# 9.0 RESPONSES TO COUNCIL FEEDBACK

# SUMMARY

## DRAWING SET 45 McLAREN STREET, NORTH SYDNEY

# ARCHITECTURAL SET AMENDED PP

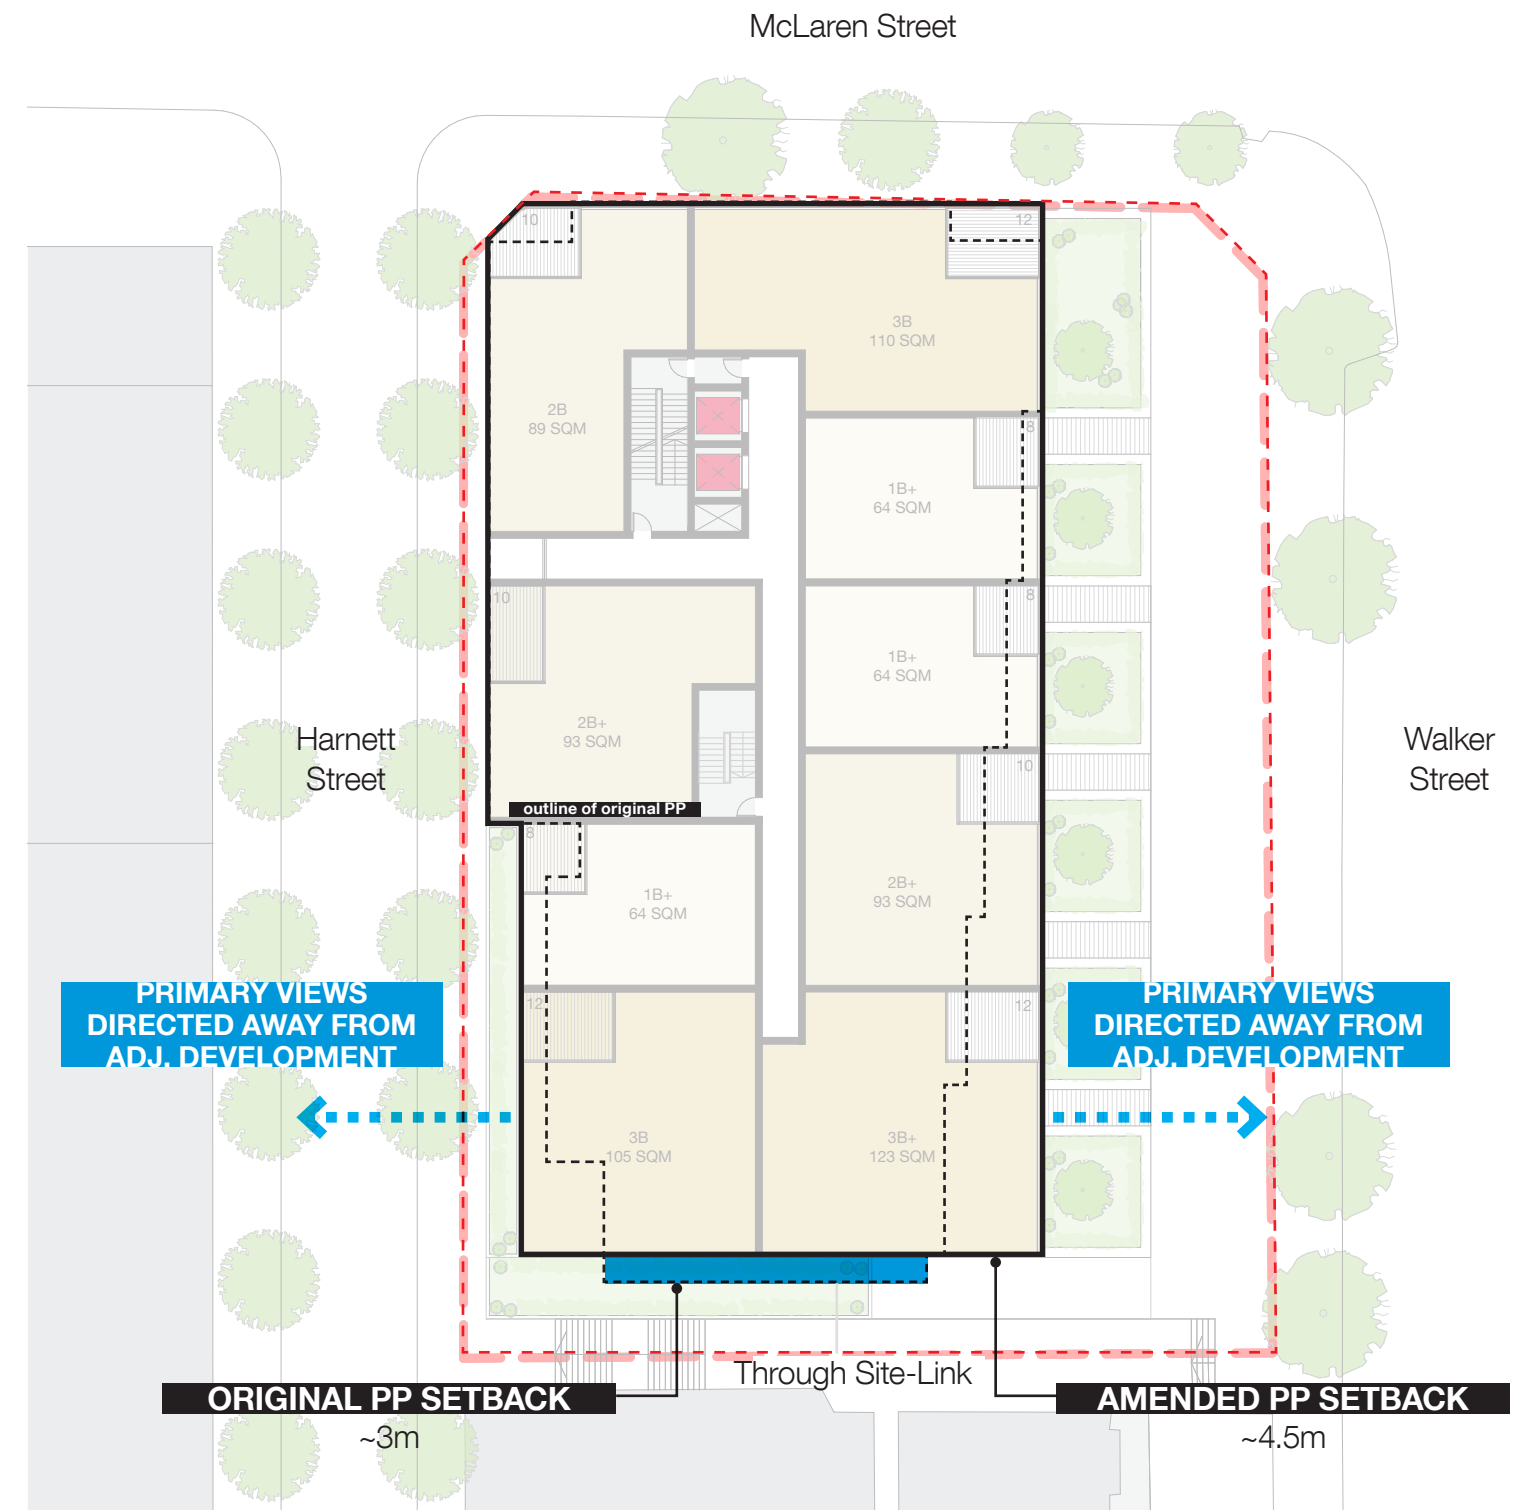
That the concept proposal be revised to:  
(c) ensure that it is appropriately setback from the southern and western boundaries consistent with the minimum requirements set by the Apartment Design Guide to ensure adequate amenity to adjoining properties and internally within the development

Tower setback to southern boundary increased from ~3m to ~4.5m.
